Staff Summary Report

SUBJECT: Hold a public meeting for Development Plan Review for **QUIK TRIP # 1400** located at 2150 East University Drive.

DPR10227 – Development Plan Review including modifications to approved site plan and building elevations.

Building Elevations

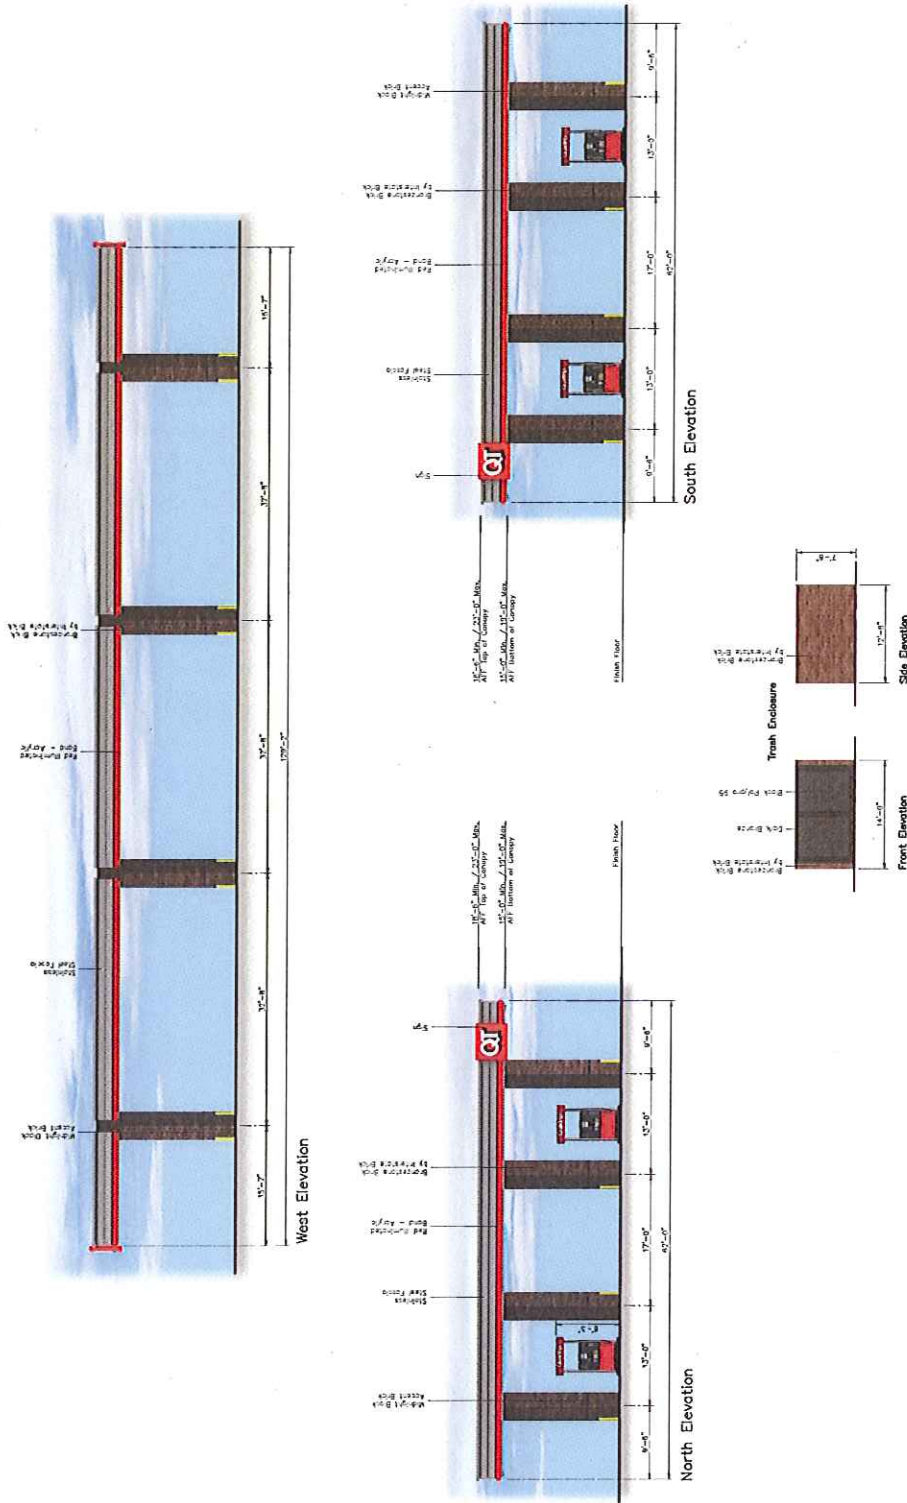
The elevations have been modified to compliment the larger model of store. In particular the following changes are noted. The canopy columns are square but are skewed at a 45 degree angle in plan. The revised convenience store enhances the simple plan rectangle by providing three levels of protruding offsets bracketing the main entrance and providing protruding triangular vestibules at each of the two side entrances. All three entrances are treated with board horizontal canopies with curving fascias. These canopies offer a greater amount of shade than that provided by the previous design.

The convenience store and canopy elevations also depart from its predecessors in the materials used. A structural brick of nominal 4 x 16 face size is set in running bond and is the basic masonry component of this building. At building walls and canopy columns, "Bronzestone" Interstate Brick (a medium reddish brown) is the field color and "Midnight Black" Interstate Brick (very dark brown) provides single course accent bands at 4.0 ft and 8.0 ft heights. The brick building envelope is capped with a "Bronzestone" soldier course. A second, black concrete masonry unit accent is provided flanking the entrances. The broad canopies and concrete masonry at the entrances provides a counterpoint to the clay masonry of the rest of the building and is a welcome accentuation for the entrances. Metal shed awnings shield the windows on either side of the main entrance. The three entrance door frames are stainless steel. Aluminum Composite Material (ACM) panels of Mica Grey cap the storefront at the entrances. Canopy fascias at entrances and over the fuel stations are finished with stainless steel and are trimmed with a red illuminated acrylic band. Cornice elements that cap the three entrances are formed stainless steel panels. The side entrance triangles extend over the lower roof of the main building body. Secondary mechanical screen panels on the building are indicated to be Polypro 95—a translucent, woven, polypropylene windscreen fabric. The secondary screen material is changed by condition of approval to match the ACM panels of the upper part of the store elevations or provide a two layer metal mesh screen.

6. The following materials and colors are approved as presented (this condition supersedes DPR10148 condition 14):
 - a. Clay Masonry Unit Field at building and columns: 4 x 16 (nominal) face, Interstate Brick – Bronzestone Brick

8. Provide additional information for the following materials:
 - a. Concrete Masonry Unit Accent frame at building entrances: Midnight (very dark brown or black) color, indicate manufacturer and type of concrete masonry face size and texture.

- d. Glazing: clear, insulated, indicate type of glazing.
 - e. Secondary Roof Screen for roof mount equipment: The Black Polypro 95 fabric screen is not acceptable on the building. Provide a durable, opaque screen material. Provide screen panels clad with ACM, Mica Grey or provide two layers of tightly woven steel mesh panels. If the steel mesh option is chosen, paint QT Brown and detail the two layers so the openings in the mesh are offset and the two layers cannot be seen through.

9. Conceal the electrical service entrance section and related electrical equipment on the rear elevation inside a masonry enclosure on the north of the store. The form detailing of this enclosure is similar to that as designed and approved for the electrical equipment enclosure for QuikTrip #1420. This condition supersedes DPR 10148 condition 16.
10. Do not use upper/lower divided glazing panels in exterior windows at grade level, particularly where lower (reachable) glass panes of a divided pane glass curtain-wall system can be reached and broken for unauthorized entry. If this mullion pattern is desired for aesthetic concerns, laminated glazing may be considered at these locations. Do not install landscaping, screen walls or any equipment that conceals the area around lower windows.
